Research Problem Review 78-14

HUMAN FACTORS EVALUATION OF A HELIBORNE ELECTRONIC WARFARE SYSTEM (AN/ALQ-151, QUICK FIX)

August 1978

Overall equipment configuration of direction finding operator's position and countermeasures operator's position. Figure 1.

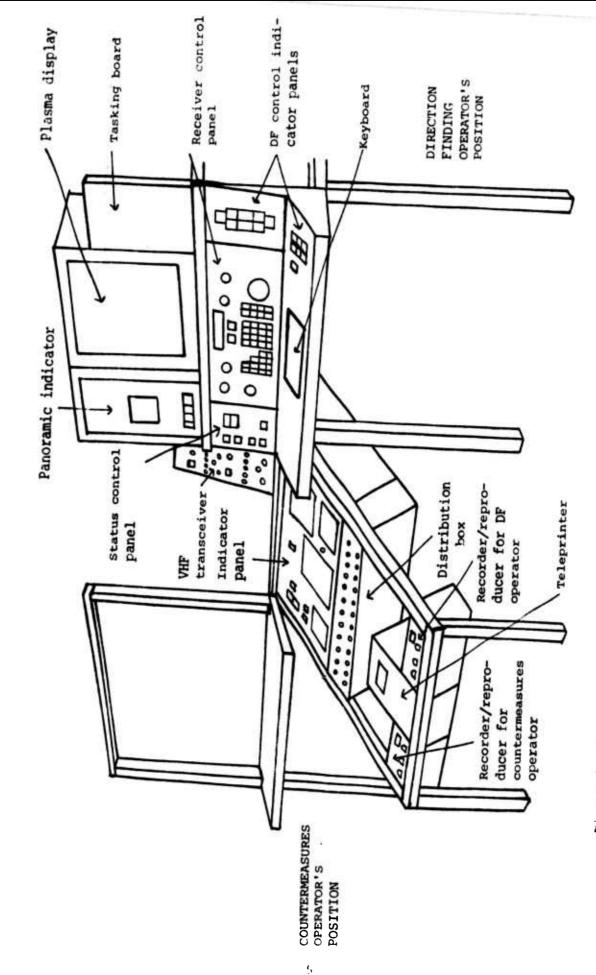
The second comment is of more importance and concerns the fact that the master caution signal and the crew call signal for the countermeasures position are not in the operator's field of view when operating the countermeasures set and, thus, he does not see either signal when activated. This problem may be eliminated by mounting the master caution and crew call signals on the countermeasures operator's worktable.

Workspace and Overall Equipment Configuration. The crew call signal and the master caution signal are not located in a position where they are readily seen when the DF operator is busy. It is recommended that these signals be moved to a position more central to the operator's field of vision. Possibilities include either side of the tuning frequency display, within the plasma display itself, or between the keyboard and the DF key. It would also be helpful to provide an auditory alarm with the visual signal.

Figure 2. Receiver control panel (ECU).

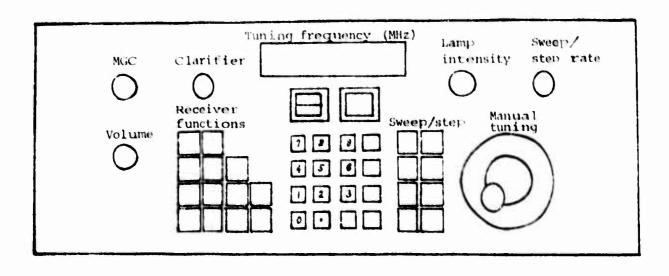
Two operators indicated that when wearing the Nomex flight gloves they sometimes entered a wrong frequency because their fingers would slip off a given numeric key and hit another one, or they would accidentally hit two keys at once. This problem was further investigated by the experiment described earlier. As explained then, four operators were tasked to enter into the RCU a series of frequencies and related information under four different experimental conditions. The results, shown in Table 1, reveal that few errors were made under any of the experimental conditions, and there were little differences in the time required to enter a list into the RCU for the "gloves on" versus "gloves off" condi-The small size of the sample precluded any meaningful statistical tests of the data. Thus, one cannot conclude from this experiment that wearing gloves and being airborne influences performance on this type of However, because the performance measures tended to show degraded performance when subjects were airborne and wearing gloves and because the sample was so small, this problem should be investigated in more detail.

Even though few errors were made, operators' comments indicated that the interkey distance on the RCU panel should be greater than the 1/2-inch minimum specified in Military Standard 1472A and Military Handbook 759 (the specified preferred interkey distance is 1 inch).

figure 1. Direction finding (DC) control indicator panel.

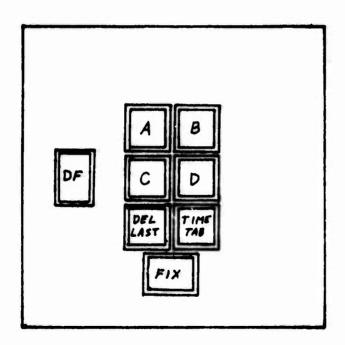
Measurements of these panels revealed that is design did not conform to the specifications of Military Standard 1472A with remeet to distance separating adjacent keys. Military Standard 1472A specifies a minimum interkey distance of 1/2 inch, whereas the present design has essentially no distance separating the keys in each panel with the exception of the DF key. Operators did not indicate that this caused any problem. All four operators, however, complained that there was a lack of feedback from the keys when they attempted to activate them. They complained that some keys had to be pressed two or three times before they were activated. This was a particular problem with the DF key because it sometimes takes the system as long as 5 or 6 seconds to determine a line of bearing after the DF key has been pushed. Operators said that sometimes they were not sure they had pressed the key hard enough to activate the DF command; this caused confusion as to whether the key should be pressed again. Such confusion and delay may involve only a few seconds, but it is possible that a threat radio could stop transmitting during that time, thus causing a failure in obtaining an LOB and perhaps ultimately a failure in fixing the threat location. To eliminate this problem, the operators suggested that a signal appear on the plasma display when the system is computing a line of bearing. Adoption of this suggestion appears to be a satisfactory way of solving the problem because the operator's attention is directed to the plasma display after he has hit the DF key, and he would therefore get immediate feedback as to whether the system was acting on the DF command. With other keys, the differential between the increasing resistance and the sudden drop in resistance that occurs when the key is activated should be increased to provide more feedback concerning whether keys have been pushed hard enough to activate their functions.

Figure 4. Recommended design of plasma panel.

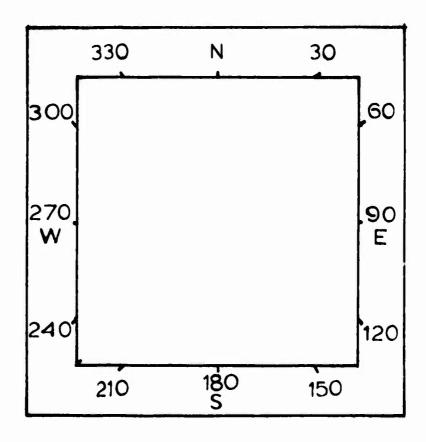
Three operators said that bearing headings should be permanently etched into the periphery of the plasma panel (Figure 4) so that the operator could rapidly indicate to the pilot the direction of a target radio.

Bearing headings should be permanently etched into the periphery of the plasma panel so the DF operator can rapidly provide target direction information to the pilot.

Figure 5. Status control indicator panel.

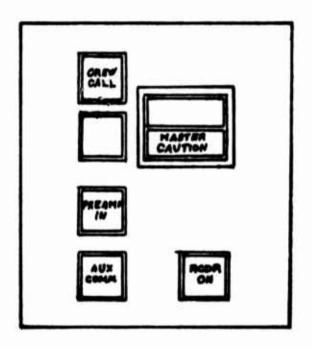
Status Control Indicator Panel. The status control indicator panel (Figure 5) consists of four pushbutton keys/signals and a master caution signal. Operators' comments were directed to the crew call signal and master caution signal. The crew call signal flashes 20 times with an orange light when activated, indicating that all operators and pilots should switch their C-1611 control set to the intercom mode. The master caution signal lights up in bright orange, indicating that a light on the master caution panel is on. The problem with both the crew call and master caution signals is that operators did not notice them while they were watching the plasma display and the DF control indicator panels on the other side of the apparatus. The problem with the crew call signal is serious because it is the only safe way pilots can indicate to the operator that they want to communicate. All pilots complained of this problem. The problem with the master caution light is also serious because prolonged inattention to a caution condition could easily lead to serious equipment malfunction. The problem with both signals could be remedied by providing an audio signal with visual signals and by relocating the signals to a more central location with respect to the

operator's activities. Ideally, this would be on either side of the tuning frequency display or in the plasma display itself. Another possible, although less desirable, alternative would be to relocate the signals between the keyboard and the DF switch.

Figure 6. Indicator panel.

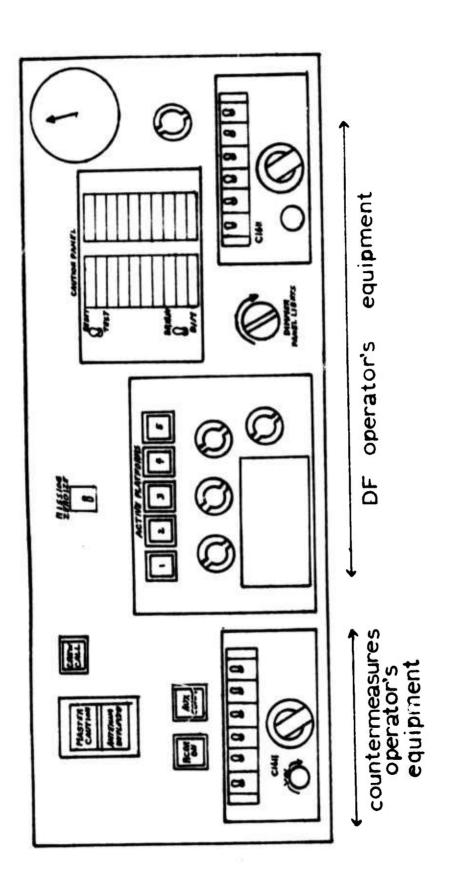
Because the Quick Fix system was tested in the single mode, operators were not able to evaluate the communications processor control indicator. With respect to the other items, there was only one comment: The visibility at night of the toggle switches on the C-1611 was poor. The length of these toggle switches was only about 1/4 inch, which is

much shorter than the minimum prescribed by Military Standard 1472A (1/2-inch for the bare hand and 1-1/2 inches for the gloved hand). None of the operators indicated, however, that they had difficulty operating these switches; it would seem that the equipment may be acceptable as it is.

Figure 7. Teleprinter controls and indicator.

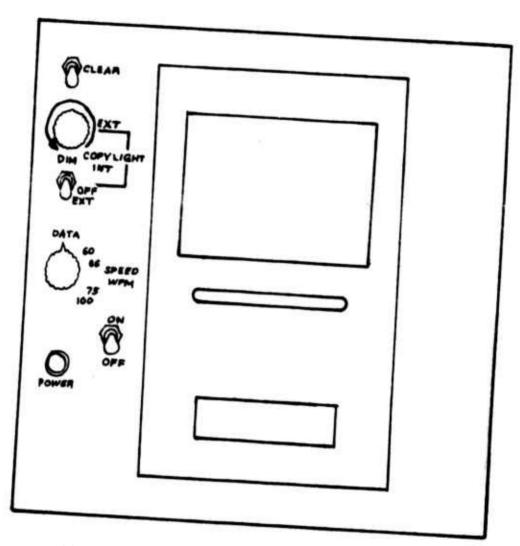
Teleprinter. The teleprinter (Figure 7) is used to print out a paper copy of messages and intelligence information that have been stored in the computer. Operators had several comments about the teleprinter. One comment concerned the size of the controls and the spacing between them. Two operators said that it is difficult to operate the controls with gloves on because the controls are too small and there is not enough space between them. It should be noted that although the toggle switches on the teleprinter just meet ungloved hand specifications (1/2 inch in length), they fall short of the gloved-hand specifications (1-1/2 inches in length) given in Military Standard 1472A. Consideration should be given, therefore, to increasing the length of the toggle switches and increasing the space between the controls so they can be easily manipulated with the gloved hand.

Another comment about the teleprinter was that a paper take-up would be helpful for rolling up the paper tape as it is printed out by the teleprinter. Currently, the paper printed out blows around if the doors are open. A paper take-up or rack would eliminate this problem.

Teleprinter. The teleprinter should be modified by including larger toggle switches and greater spacing between the controls so that operation with gloves is easier.

Figure 8. Recorder/reproducer.

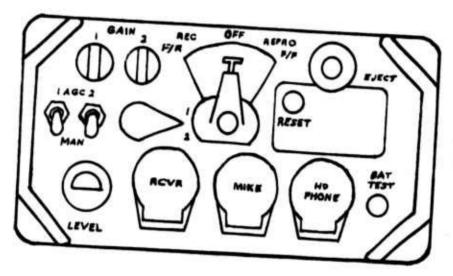
The major complaints about this piece of equipment were similar to those of the teleprinter; namely, the controls are too small to use easily with the gloved hand and too difficult to see the controls, especially if the operator is busy intercepting and performing other DF functions.

Measurements of this equipment showed that the toggle switches do not conform to gloved-hand specifications, and the distance between the toggle switches and gain control knobs (.25 inch) are short of Military Standard 1472A minimum specifications (1 inch). In addition, the sides of the recorder extend beyond the face panel on which control knobs and toggle switches are attached, further restricting the free space around the controls. This condition is also characteristic of the teleprinter.

Another criticism of the recorder, made by two operators, was that it is difficult to extract the tape cassette, a problem if the operator were airborne and needed to change tapes quickly. It should be noted, however, that normally one tape cassette will be sufficient to last the entire mission, so this should not be a problem. If the recorder were started early in the mission, however, and then the operator forgot about it (as one said he had done), then it would be possible to run out of tape during a mission. This leads to another problem, namely, that there is no indication when the tape has run out. A signal to indicate this perhaps should be built into the recorder.

A means should be provided for ejecting the tape cassette when the operator wishes to change tapes.

Figure 9. Pilot's and copilot's instrument panel and pedestal.

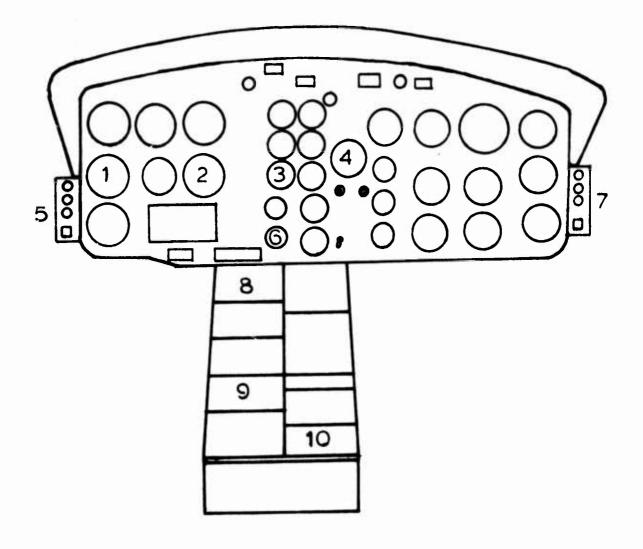
Bearing-Distance-Heading Indicator (BDHI). This indicator receives input from the Quick Fix mission equipment and indicates the bearing, distance, and heading of a selected target radio. The BDHI is located next to the copilot's countermeasures antenna control display (Figure 9).

The primary comment the pilots made about the BDHI was that they seldom used it because it was not completely functioning and was too difficult to read from the pilot's position. Pilots suggested that the BDHI be moved to a more central position so that both the pilot and copilot could see it, and that it be made completely functional.

Overall Equipment Configuration. Pilots were relatively dissatisfied with the overall configuration and location of their Quick Fix equipment. They felt that the BDHI needs to be located in a central position so that both pilot and copilot can see it. The equipment could be located just below the Radar Hostile Air Warning System indicator or placed between the copilot's vertical velocity indicator and the transmission oil pressure indicator (Figure 9). Either location would enable both pilots to view the BDHI.
